# Common Structural Rules for Bulk Carriers, January 2006

## Rule Change Notice 2 February 2008

## Technical Background for Rule Change Notice 2 February 2008

**Figure 25: Hatch corner insert plate**

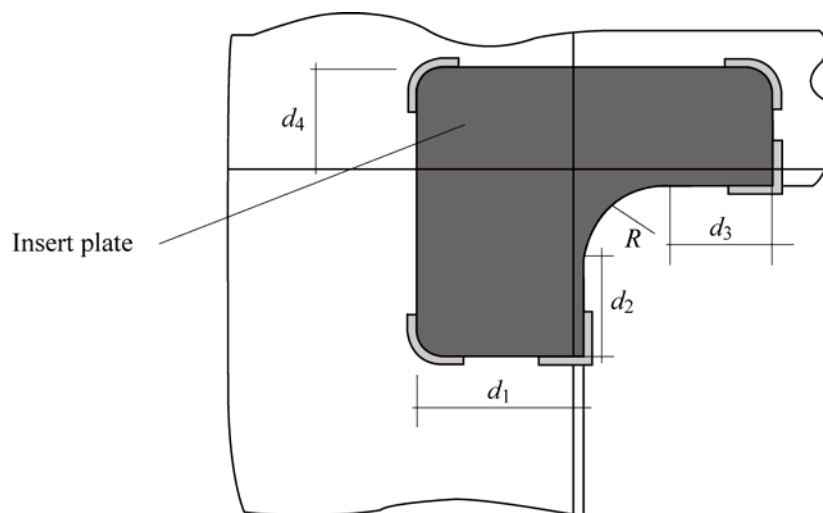
For ships having length  $L$  of 150 m or above, the corner radius, the thickness and the extent of insert plate may be determined by the results of a direct strength assessment according to Ch 7, Sec 2 and Sec 3, including buckling check and fatigue strength assessment of hatch corners according to Ch 8, Sec 5.

For ships having length  $L$  of 150 m and above, FEA including buckling check, hull girder ultimate strength check and fatigue check of hatch corners are required by the CSR for bulk carriers.

Therefore, it is considered that the extent of insert plate can be determined based on such evaluation result in lieu of the requirement of this sub-section.

Where insert plates are required, the arrangement is shown in Fig 25, in which  $d_1$ ,  $d_2$ ,  $d_3$  and  $d_4$  are to be greater than the ordinary stiffener spacing.
